AX
	Application No.	Applicant(s)	
	10/692,376	TAMIYA ET AL.	
Notice of Allowability	Examiner	Art Unit	
	Marissa J. Detschel	2877	
The MAILING DATE of this communication app All claims being allowable, PROSECUTION ON THE MERITS IS herewith (or previously mailed), a Notice of Allowance (PTOL-85 NOTICE OF ALLOWABILITY IS NOT A GRANT OF PATENT R of the Office or upon petition by the applicant. See 37 CFR 1.313	G (OR REMAINS) CLOSED in this ap ) or other appropriate communication RIGHTS. This application is subject t	pplication. If not include n will be mailed in due	ed course. <b>THIS</b>

## **EXAMINER'S AMENDMENT**

FIG. 1
PRIOR ART

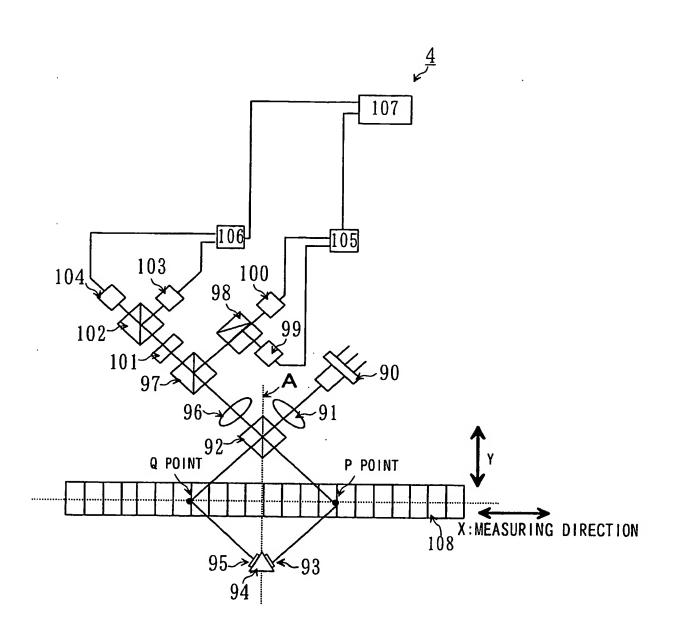
- In regards to Figure 1, a label for -- Prior Art-- has been added.
- In regards to Figure 2, the label "Q POING" has been replaced with -- Q POINT-
- In regards to claim 2, line 2, the phrase "on one of ends" has been replaced with --on one end--.
- In regards to claim 4, line 2, the phrase "in stack perpendicularly" has been replaced with --in a stack perpendicular--.
- In regards to claim 15, line 4, the phrase "in stack perpendicularly" has been replaced with --in a stack perpendicular--.
- In regards to claim 18, line 4, the phrase "in stack perpendicularly" has been replaced with --in a stack perpendicular--.
- In regards to claim 20, line 1, the phrase "first and light sources" has been replaced with --first and second light sources--.
